SUBJECT: FORWARDS ADDL INFO RE STRUCTURAL ANALYSIS & RADIOLOGICAL EFFECTS OF PROPOSED INSTALLATION OF HIGH CAPACITY SPENT FUEL RACKS IN POOL. INCLUDES QUESTION RESPONSES, NON PROPRIETARY DRAWINGS, & ADDL TECH SPEC CHANGE. *SwBph*

Re: Oconee Nuclear Station  
Docket Nos. 50-269, -270

ATTACHMENT 1

QUESTION RESPONSES

## TYPICAL BEARING PAD

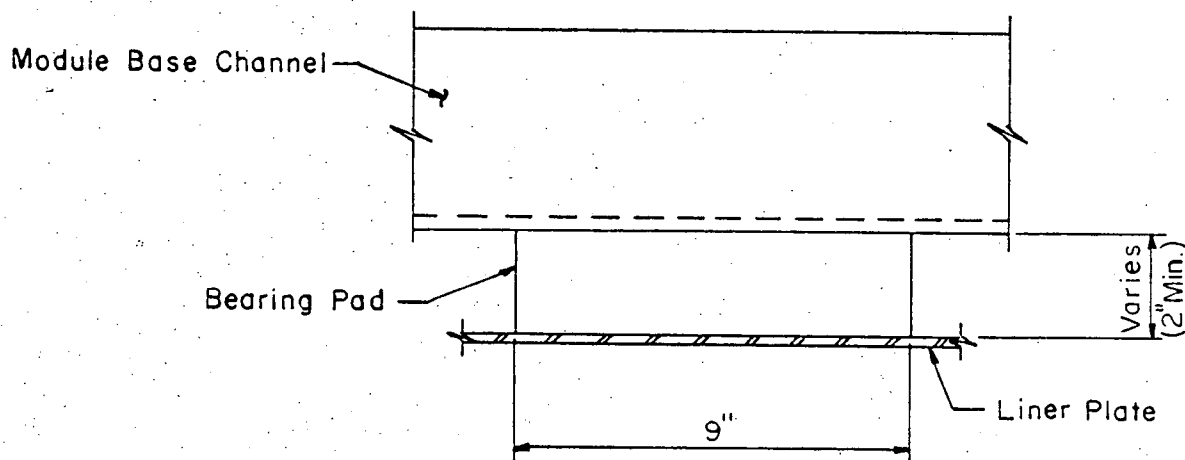
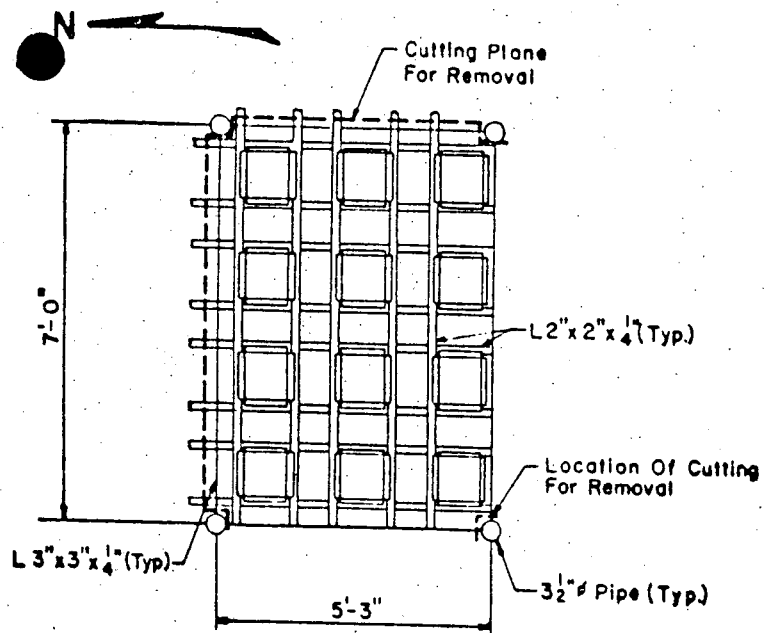
On page 4-2 you refer to "bearing pads". Provide a sketch of typical pad and its connections to the module and to the liner if any.

- b) The "U" channels sit on 12 bearing pads per module as shown in Figures 1 and 5. These pads are not attached to the "U" channels or the pool liner. They serve to elevate the modules above the "bent plates" (also in Attachment 2) which form part of the existing rack structure. By including these pads it alleviates the need to grind the existing structure flush with the liner thereby improving ALARA dose levels. Sufficient area is provided to give necessary frictional contact at both the module/pad and pad/liner interfaces.

Figure 1 of Attachment 2 provides the requested sketch. Please refer to response to Question 8 for further explanation.

EXISTING RACK STRUCTURES  
 ("BENT PLATES" SKETCH)  
 OCONEE NUCLEAR STATION  
 Figure 3

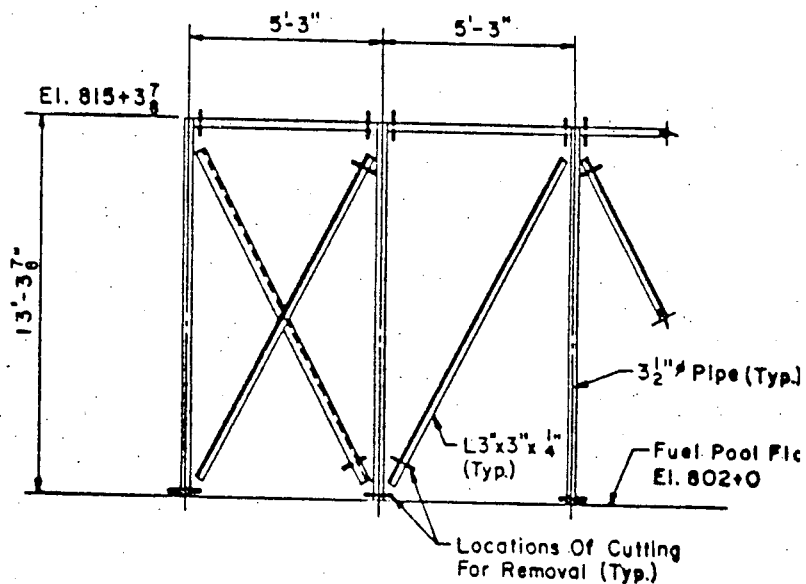
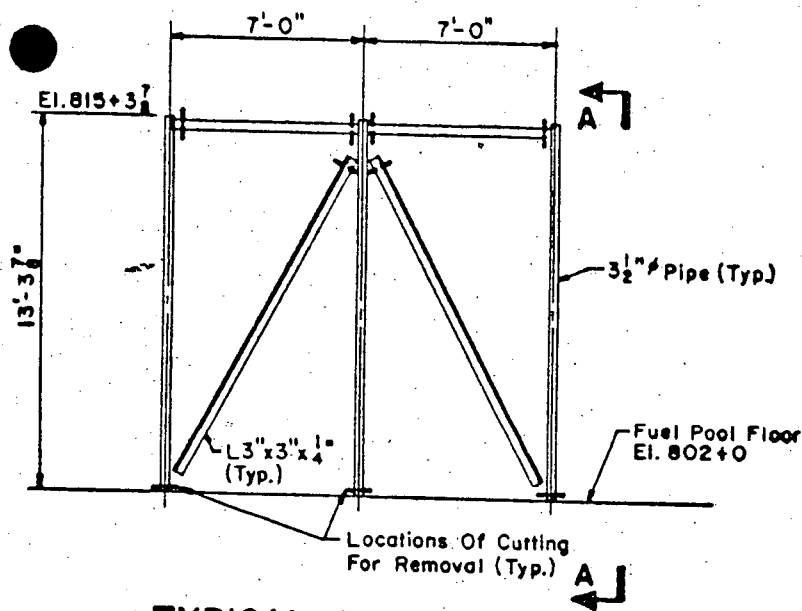
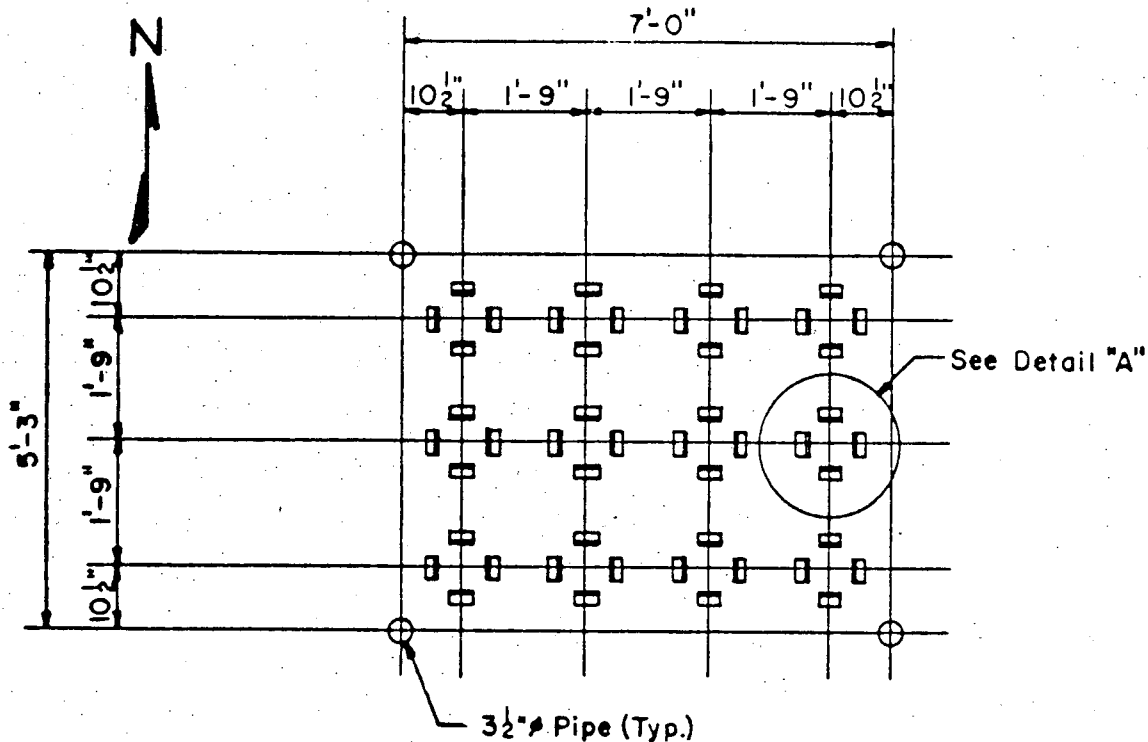
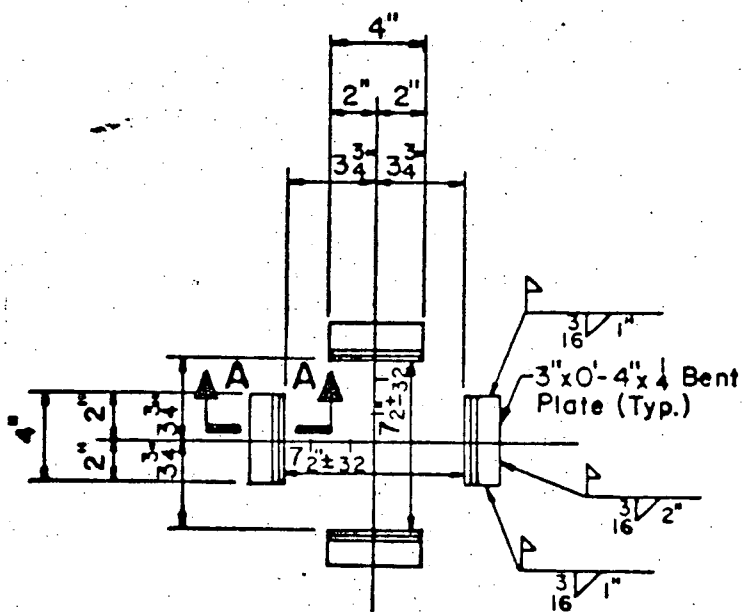
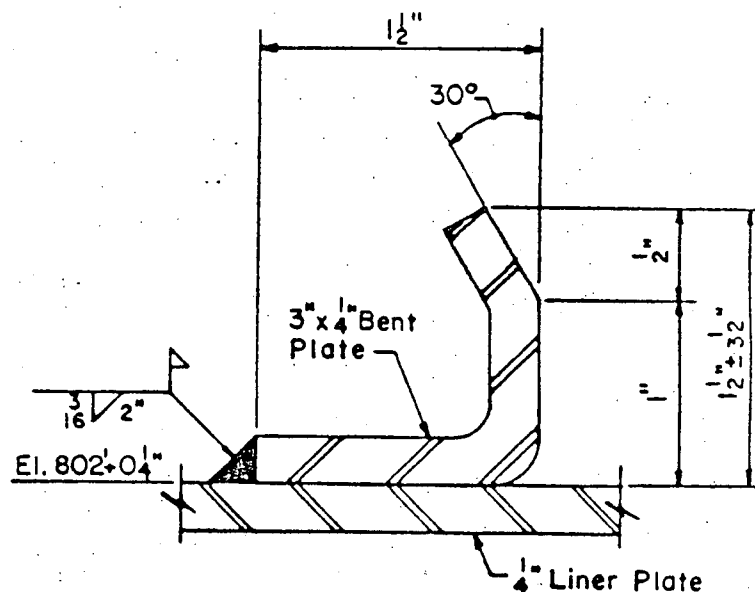
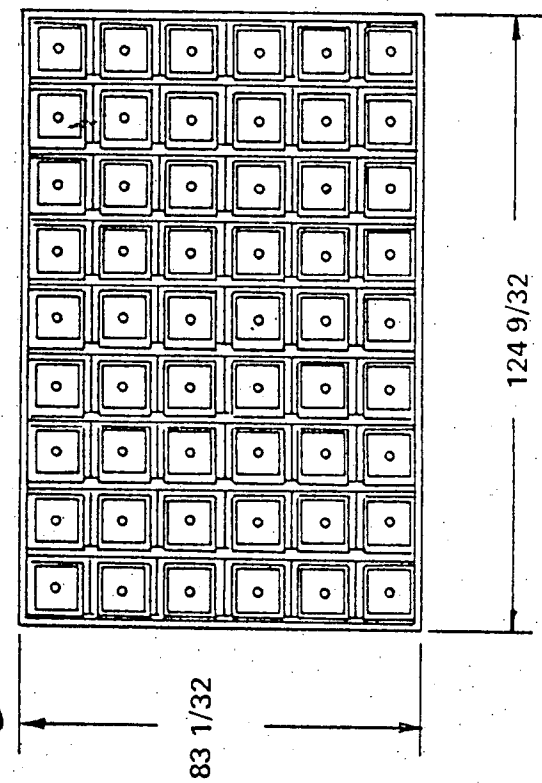
(Page 4-1) You state that "...Underwater divers will be used to cut the pipe supports of the existing racks approximately 1" above the embedded floor plate to which they are welded. Connecting angles will then be cut..." Provide sketches explaining this operation.

On page 4-3 you refer to "bent plates" supporting the old racks and welded to the liner. Sketch these bent plates, indicate their relationship to the "pipes" mentioned in our question (13) above and describe the method of removal of these bent plates if required.

Figures 2 and 3 of Attachment 2 provides sketches to show the general layout of typical existing rack structures and the locations of expected cuts for the removal operation.

Figures 2 and 3 of Attachment 2 provide requested sketches. The bent plates are welded to the liner to form the bottom of the fuel cavities as shown in Figure 3. The pipes form the vertical structure of the "racks" themselves. In that the current racks are not of the can-type design, there are no cavities as such. The "pipes" and "angles" form a framework which support and connect the upper and lower portions of the racks.

Figure 1  
FUEL RACK MODULE

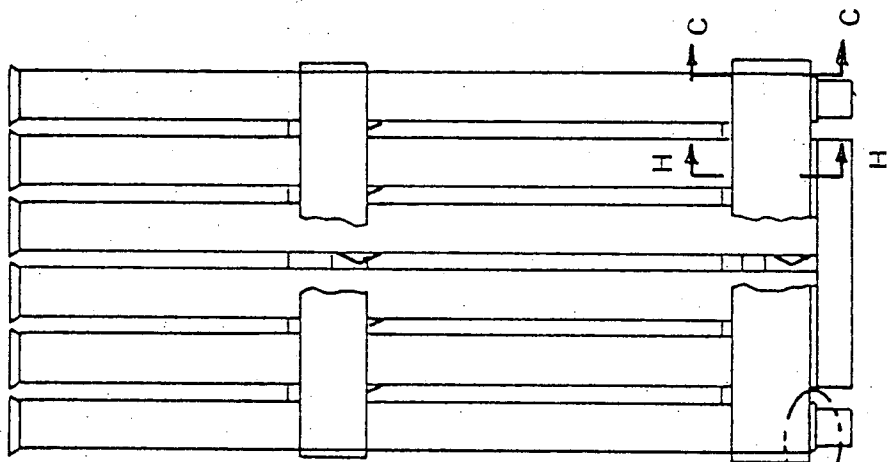
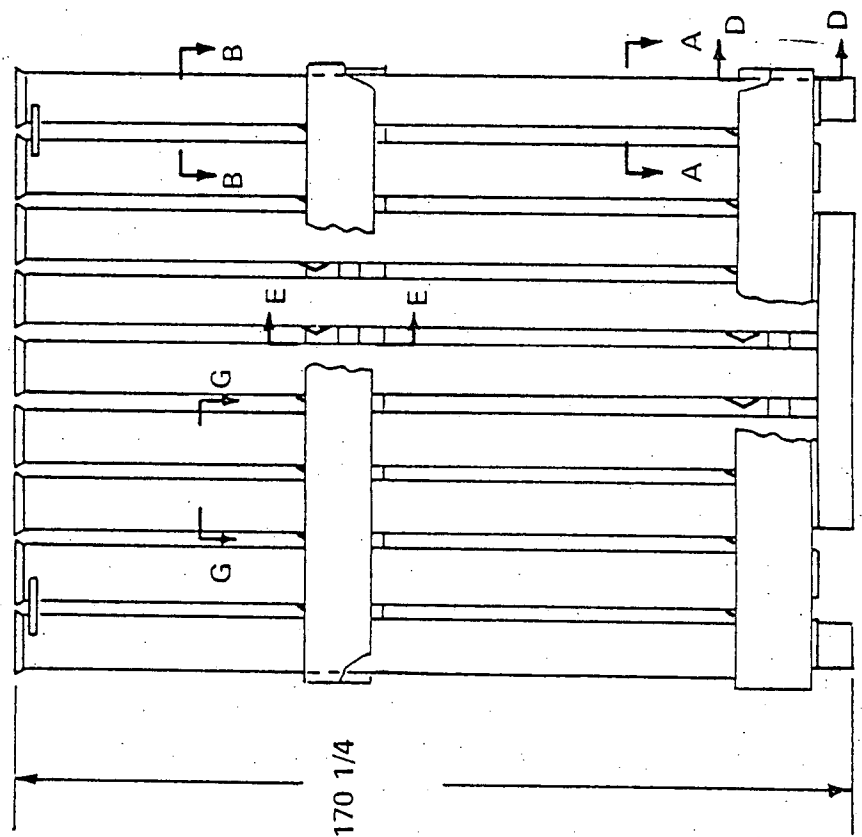
(Page 22) Provide a more detailed sketch of typical module than p.8, 2.2-2. Include details of "chevron grid structure," supporting "U" channels, connections between various elements. Provide dimensions, thicknesses, size of gaps and in general all the information needed to evaluate strength of elements. Make clear how the modules are supported.

(Page 24) You do not provide details of the base of the module. Provide a sketch and explain in detail the path along which the forces are transmitted to the bottom of the pool.

The "base" of the modules and the path over which the loads are transmitted are shown in sketches/drawings included in Attachment 2. To clarify the path, the following description is provided.
